Access Compliance Report

Public Rights-of-Way

(Curb Ramps)

Intersection ID: 43370	Main Street: SIMONTON_DR	Cross Street: SOBECK_LN	Location: S
ADA ID: 6C6815BA89A8	Ramp Type: Perp	Initial Pass/Fail: Pass	Overall Compliance: No
Severity Score: 0.25			
Codes/Mitigation Info/Possible Solution		Field Measurements/Component Compliance

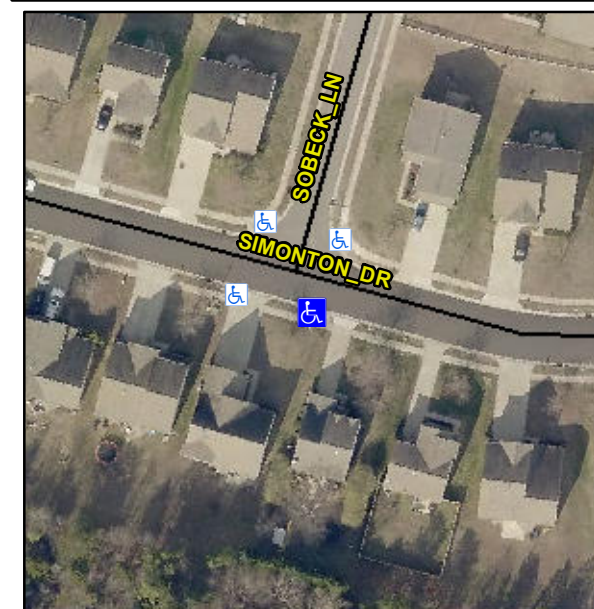
Not Found, R304.2.2-Perp, R304.3.2-Para, R304.5.3

Compliance	Description	Data	Compliance	Description	Data
N/A	Ramp Length (in)	48.0	Yes	Ramp Slope (%)	7.8
Yes	Ramp Width (in)	48.0	Yes	Ramp XSlope (%)	4.7
N/A	Flare Type LT	Sloped	N/A	Flare Type RT	N/A
N/A	Flare Slope LT (%)	4.2	Yes	Flare Slope RT (%)	6.1
N/A	Flare Traversable LT?	Yes	N/A	Flare Traversable RT?	Yes
Yes	Landing Length (in)	48.0	Yes	DWS Provided?	Yes
Yes	Landing Width (in)	48.0	Yes	DWS Contrast?	Yes
No	Landing Slope (%)	2.5	Yes	DWS Length (in)	24.0
Yes	Landing X Slope (%)	4.7	Yes	DWS Full Width?	Yes
N/A	Landing Curb? (Y/N)	No	Yes	DWS Offset (in)	1.0
N/A	Shared Landing?	No			
Yes	Gutter Ponding?	No	Yes	Gutter Slope (%)	4.6
Yes	Gutter Lip Ht (in)	0.0	No	Gutter X Slope (%)	6.1
N/A	Painted X Walk1?	No	N/A	Painted X Walk2?	N/A
	X Walk 1 Direction	To NE		X Walk 2 Direction	N/A
N/A	X Walk 1 Width (in)	N/A	N/A	X Walk 2 Width (in)	N/A
	X Walk 1 Slope (%)	5.8		X Walk 2 Slope (%)	N/A
	X Walk 1 X Slope (%)	5.4		X Walk 2 X Slope (%)	N/A

**Remove & Replace Entire Ramp.
Remove & Replace Gutter.**
